Record of Executive Business and Chief Executive's Order

Reg. Reference: SDZ23A/0004 **Application Date:** 10-Feb-2023
Submission Type: New Application **Registration Date:** 10-Feb-2023

Location: In the townland of Adamstown, Lucan, Co. Dublin
Applicant Name: Clear Real Estate Holdings Limited
Application Type: SDZ Application

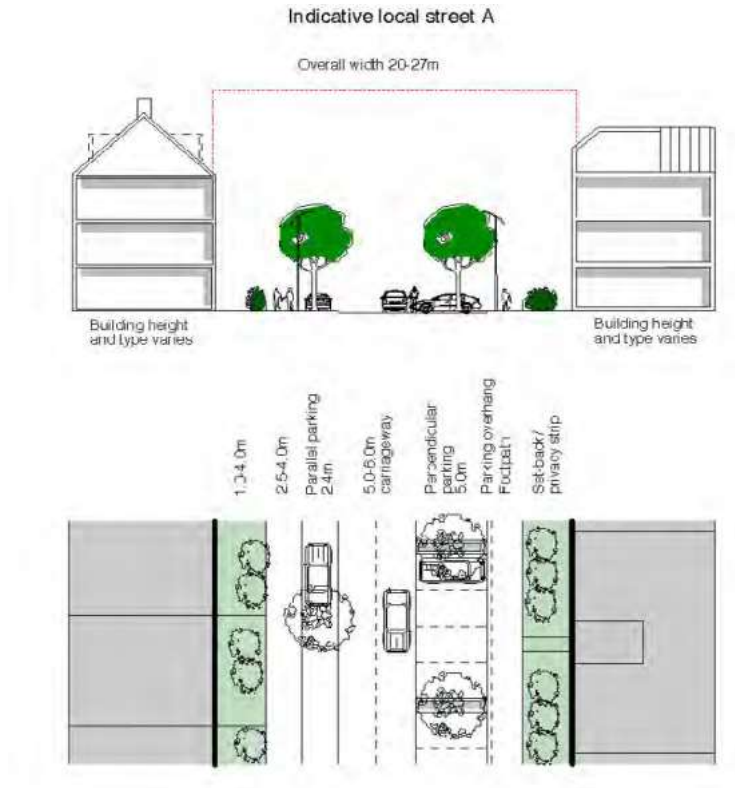
The additional local street to the south of the link street is to the rear of the duplex and does not meet the avenue. There are therefore no implications for any of the fixed frontages.

Figure 2.2.6 Example Local Streets including Homezones (Intimate Scale)

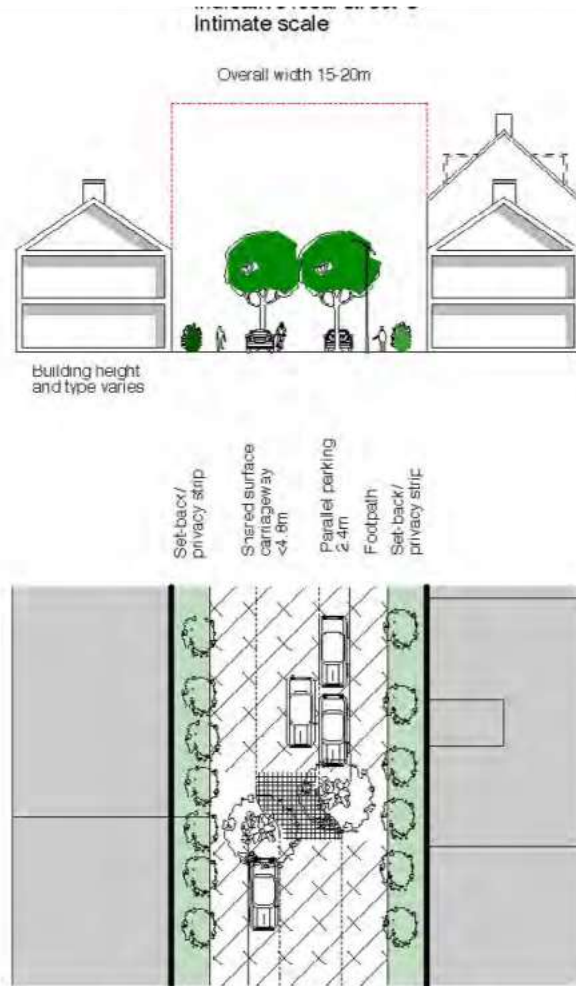
Each of the proposed streets is assessed below. It is noted that the Planning Scheme allows for 60% of car parking to be on curtilage:
